Addendum No. Three

Date: August 9, 2022
Project: Putnam County Rec. Department- Splash Pad & Pavilion, SE No. 2021-159
Engineer: Simonton Engineering, LLC.
Greensboro & Hinesville, Georgia

Questions and Responses #2

Date: August 9, 2022
Project: Putnam County Rec. Dept. Splash Pad & Pavilion, SE No. 2021-159
Client: Putnam County Recreation Department

Splash Pad Plan

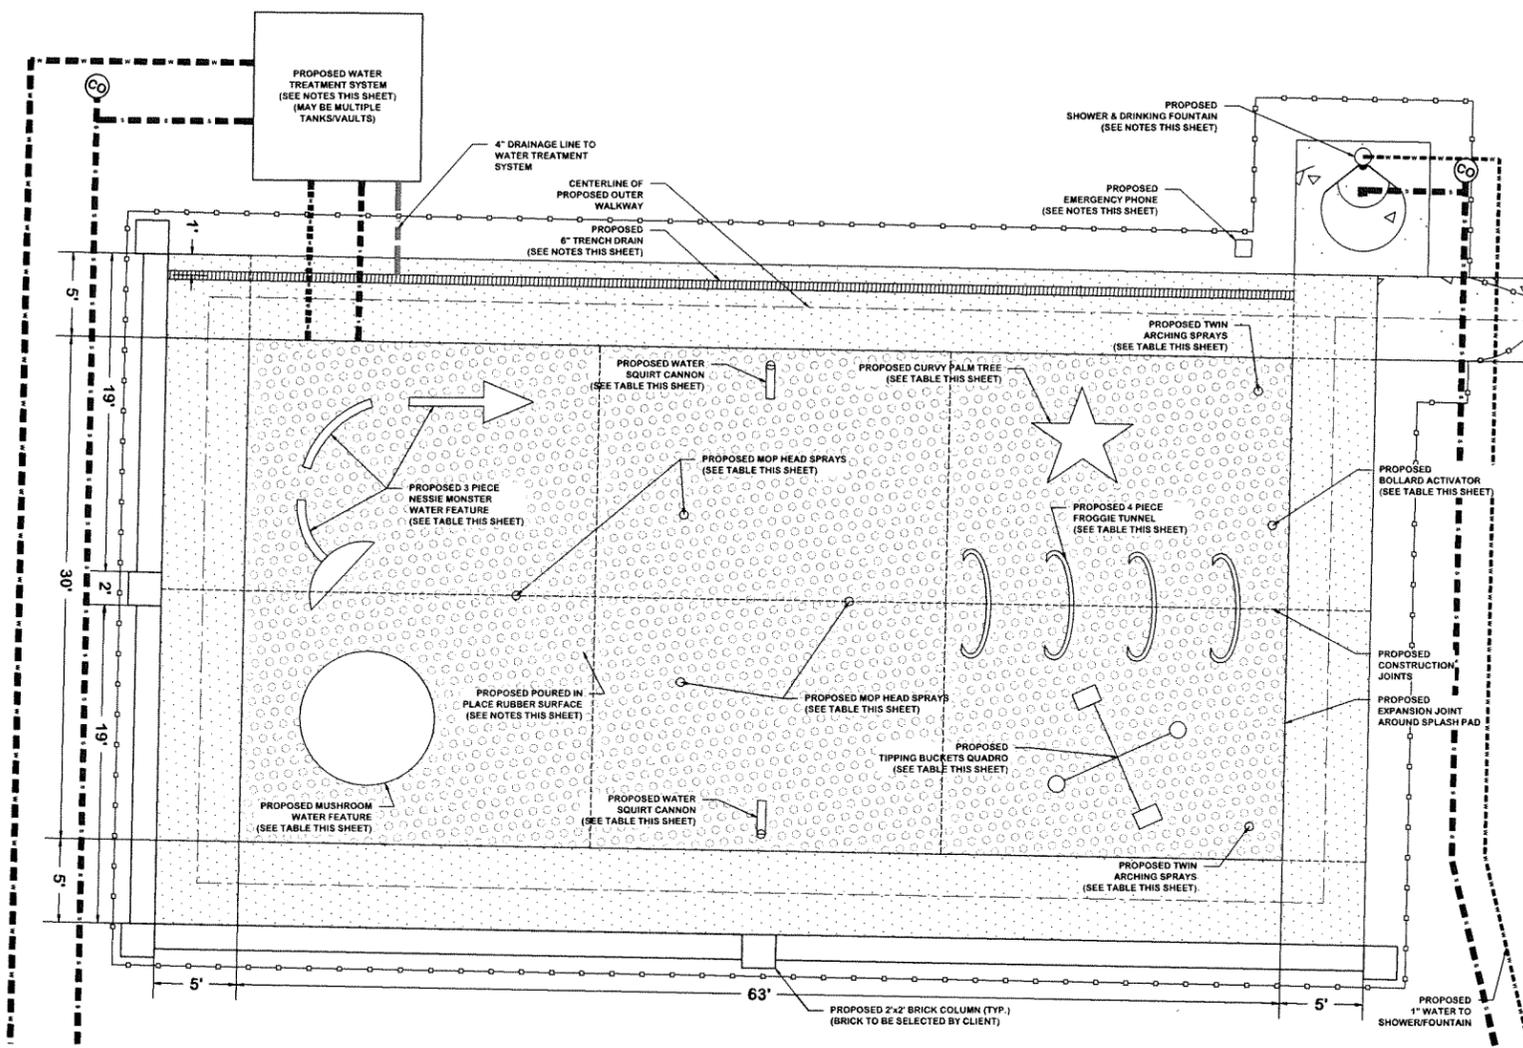
DRAWING COMPLETED BY: CORY JOHNSON, E.I.T.
REVISED: 8-9-2022 MODIFIED SIGNAGE NOTES

- SIGNAGE NOTES:**
- THE FOLLOWING SHALL BE WRITTEN ON THE SIGNAGE IN 1" LETTERS POSTED AT THE SPLASH PAD:
1. PUTNAM COUNTY RECREATION DEPT. SPLASH PAD RULES
 2. BATHING PROHIBITED.
 3. CHILDREN SHALL NOT USE FOUNTAIN WITHOUT AN ADULT IN ATTENDANCE
 4. CHILDREN THREE YEARS OLD AND YOUNGER, AS WELL AS ANY CHILD NOT POTTY TRAINED, MUST WEAR SNUG FITTING PLASTIC PANTS OR A WATER RESISTANT SWIM DIAPER
 5. NO GLASS ARTICLES ALLOWED IN OR NEAR FOUNTAIN
 6. NO RUNNING OR ROUGH PLAY ALLOWED.
 7. CLOSED DURING HEAVY RAIN OR WHEN THUNDER AND LIGHTNING CAN BE SEEN OR HEARD
 8. NO FIRE ALLOWED IN THE FOUNTAIN.
 9. IN CASE OF AN EMERGENCY, CALL 911.
 10. EATON POLICE AT 706-485-3551.
 11. PUTNAM COUNTY FIRE DEPT. AT 706-485-0465 OR DR. PUTNAM COUNTY EMS AT 706-485-9096
 12. SPLASH PAD ADDRESS: 140 RECREATION RD, EATON, GA 31024

DATE: April 19, 2022
FILE NO: 2021-159PRU
SHEET: C 2.5

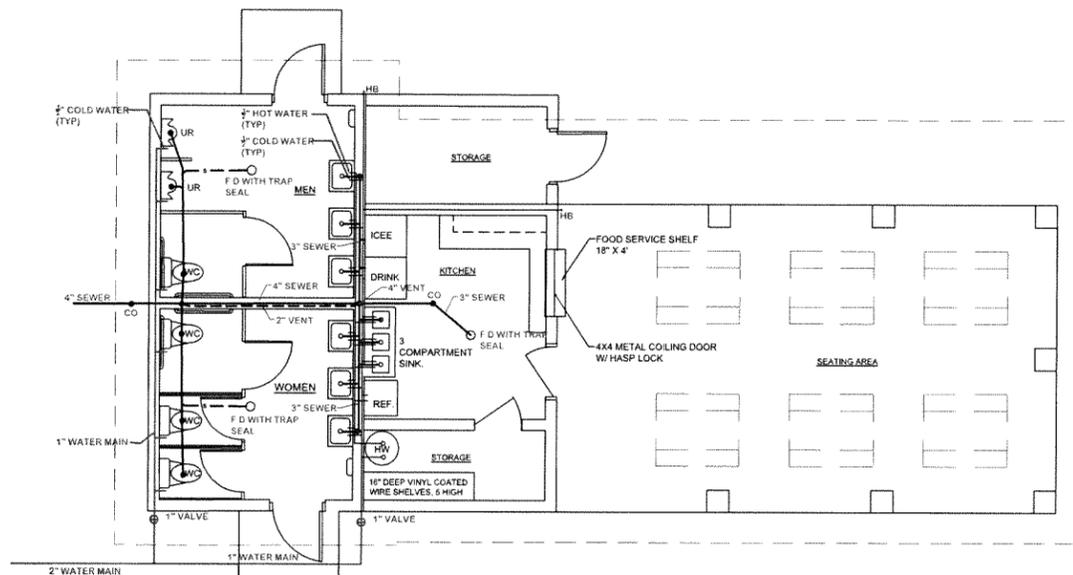
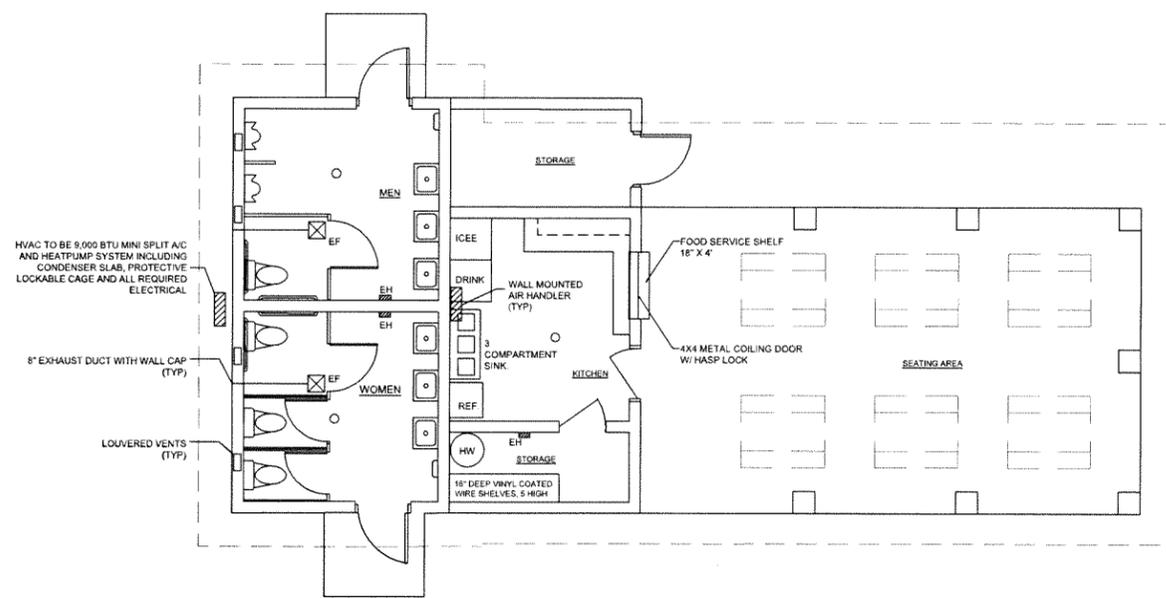
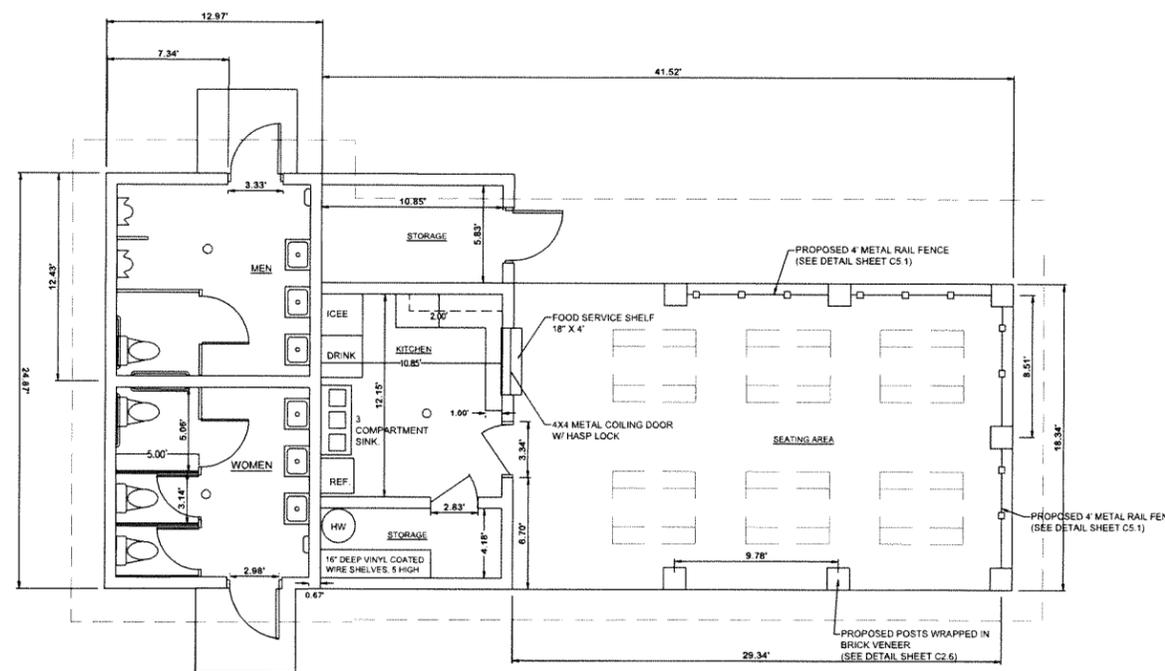
Clarification, Note #4 Sheet C2.5:

- Electrical shall provide one additional NEMA L6-30 receptacle on an additional 2P 240V circuit fed from Panel A for the Icee machine. Other devices and circuits may be rearranged within the kitchen as necessary. Electrical drawing revisions will be issued to reflect these changes prior to construction.

- 5) *Are the seating area tables to be included and if so any specification? - Rob Shurley (Renfroe Construction Company)*

- 6) *What material will be used for the toilet partitions? - Rob Shurley (Renfroe Construction Company)*

Response – Seating area tables to match existing Uline 6’ Picnic Table model number H-10002BLU. Refer to the Notes on Sheet C2.5 included in Addendum #3.

Response – Bathroom Panels to be commercial grade steel powder coated partition system by “One Point Partitions”. Color shall be as selected by the owner. Refer to the Notes on Sheet C2.5 included in Addendum #3.

1. BATHROOM PANELS TO BE COMMERCIAL GRADE STEEL POWDER COATED PARTITION SYSTEM BY "ONE POINT PARTITIONS". COLOR SHALL BE BROWN AS SELECTED BY THE OWNER.
2. TABLES IN PAVILION SHALL BE FURNISHED BY THE CONTRACTOR TO MATCH EXISTING ULINE 6' METAL PICNIC TABLE MODELS NUMBER H-10002BLU.
3. BATHROOM DOCK LOCKS SHALL BE CAPABLE OF TIMER SCHEDULE LOCK AND UNLOCK FEATURE. KEYLESS ENTRY FEATURE TO ENTER USING A CODE AFTER HOURS, KEYED FOR EMERGENCY ACCESS USING A KEY, INTERIOR PUSH TO EXIT BUTTON BY MAGLOCKS OR EQUAL.
4. ELECTRICAL PLAN ADDITION: CONTRACTOR TO SUPPLY ONE 240 VOLT SINGLE PHASE CIRCUIT FOR ICEE MACHINE.
